SUMMARY
OF

EXHIBITS ONE TO SIXTEEN

for Self and as President of Cosmopolitan Enterprises
of Victoria, Licensee of KTXN-FM

EXHIBIT (14)

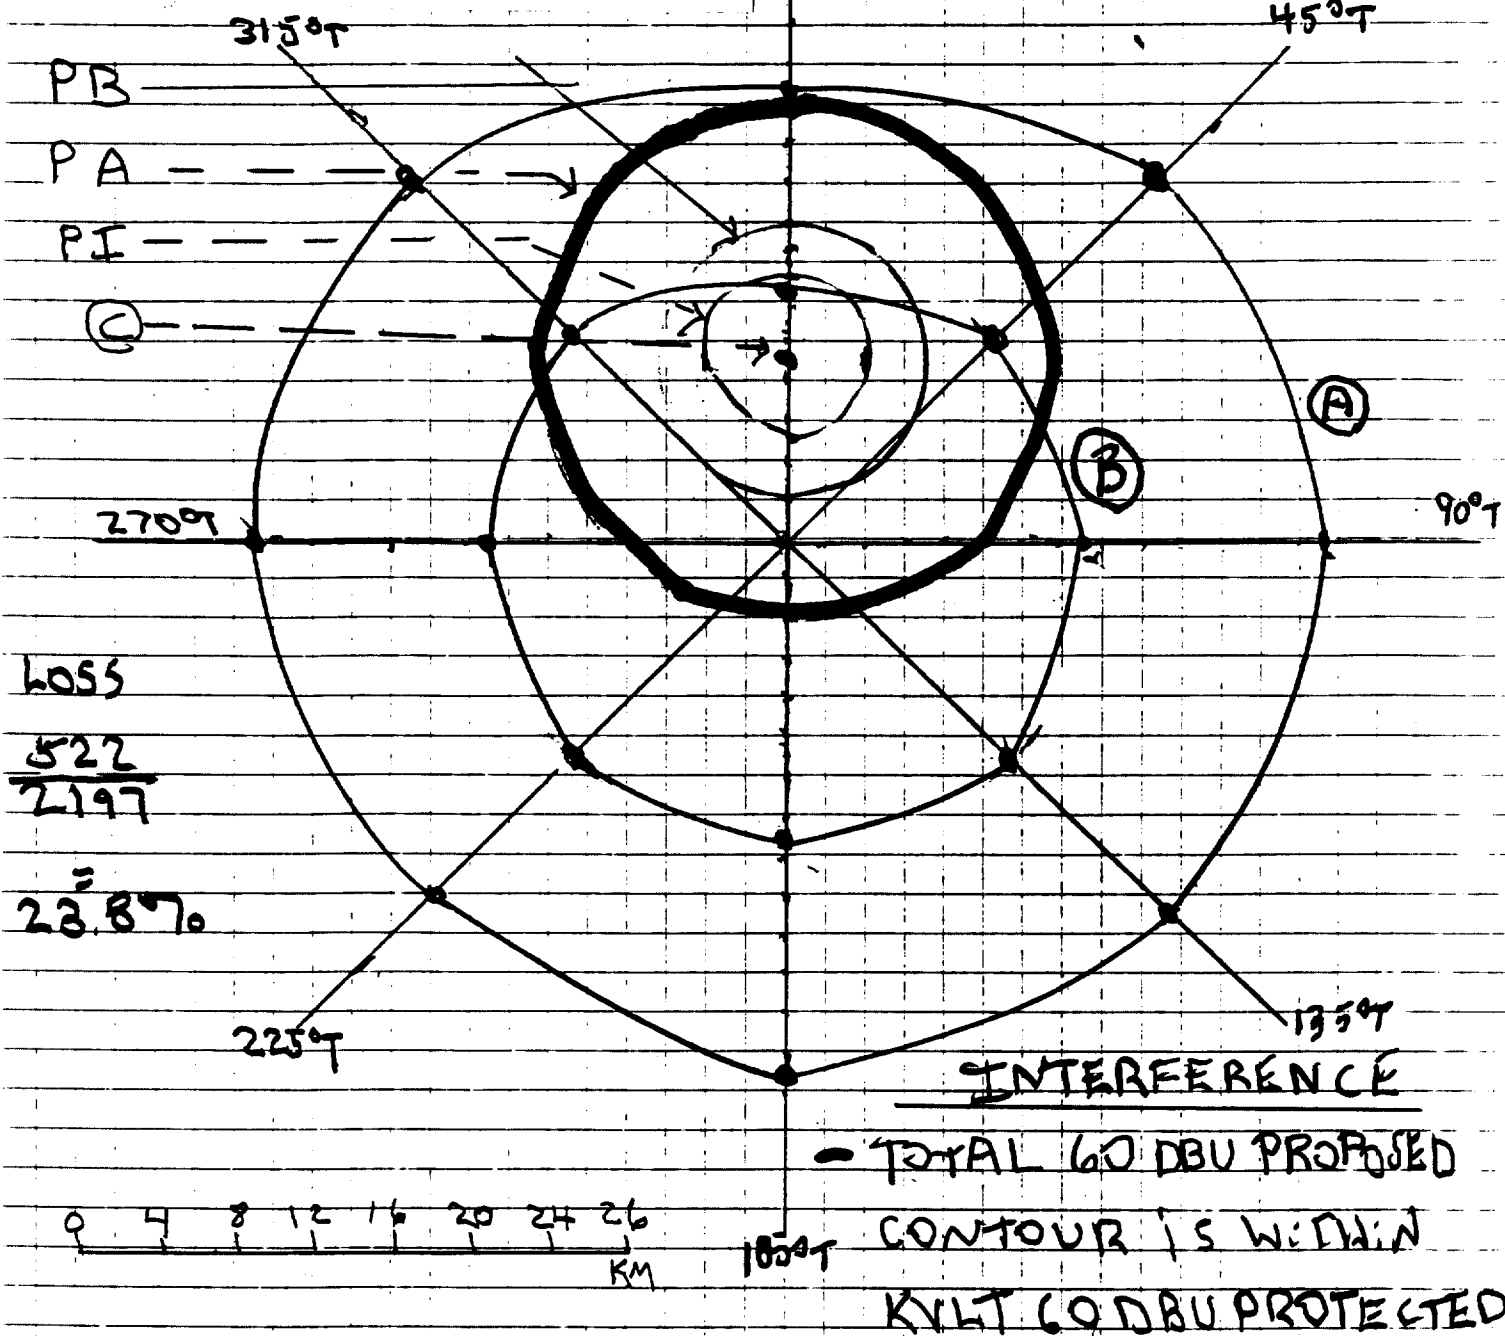
14. Exhibits eleven through sixteen are concerned with class A Fm station KVLTV with 6 kilowatts. In eleven it is shown that the city limits of Victoria are not served by KVLTV 70dbu--see area around Walmart. This is due to short spacing to Yoakum, Texas KYKM-FM -- a first adjacent channel. Thus the site of convenience at Walmart is outside KVLTV 70 dbu, but still inside its 60 dbu contour --thus interference is still caused both to the existing station and to the proposed station. In exhibit twelve it is shown that interference is caused to KVLTV from the proposal at Norwest and both stations will suffer interference. KVLTV will suffer a loss of 23.8 % of its 60 dbu protected contour area.

EXHIBIT (16)

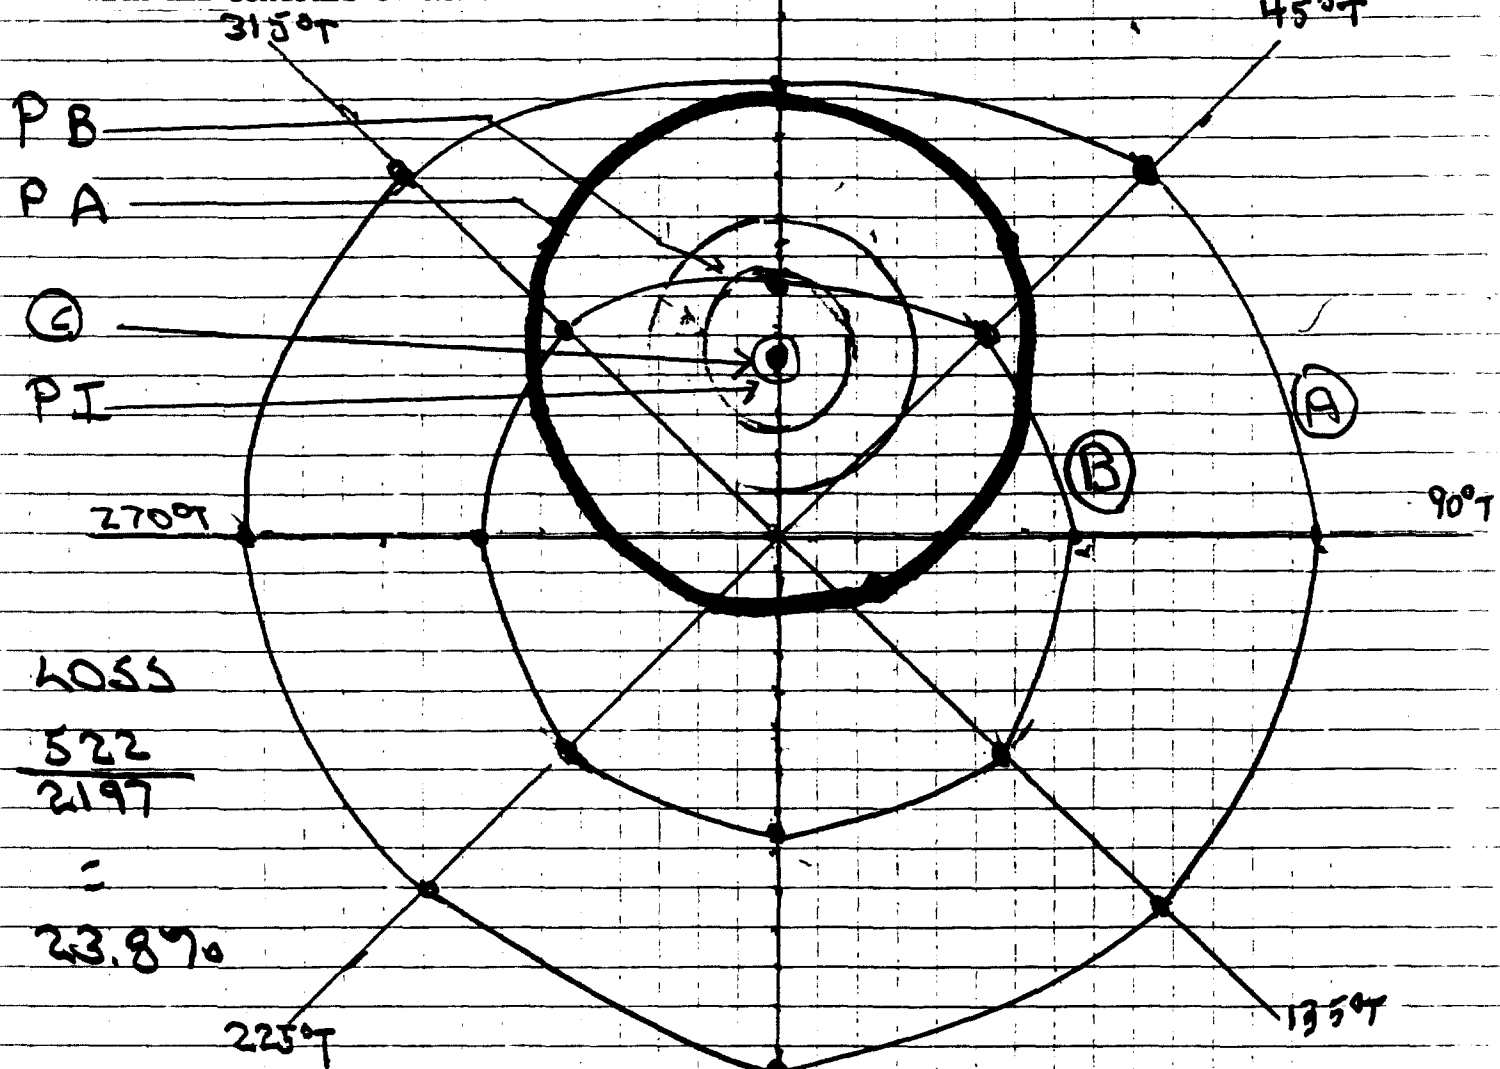
15. In sixteen, KVLTV will lose over 50.4% of its 60 dbu contour area as a result of a station located at Walmart. The amount interference will not change if the new station is on the second or the third adjacent channel. There is no overlap of KVLTV 100 , or 80 dbu contours with either the Norwest or the Walmart station.
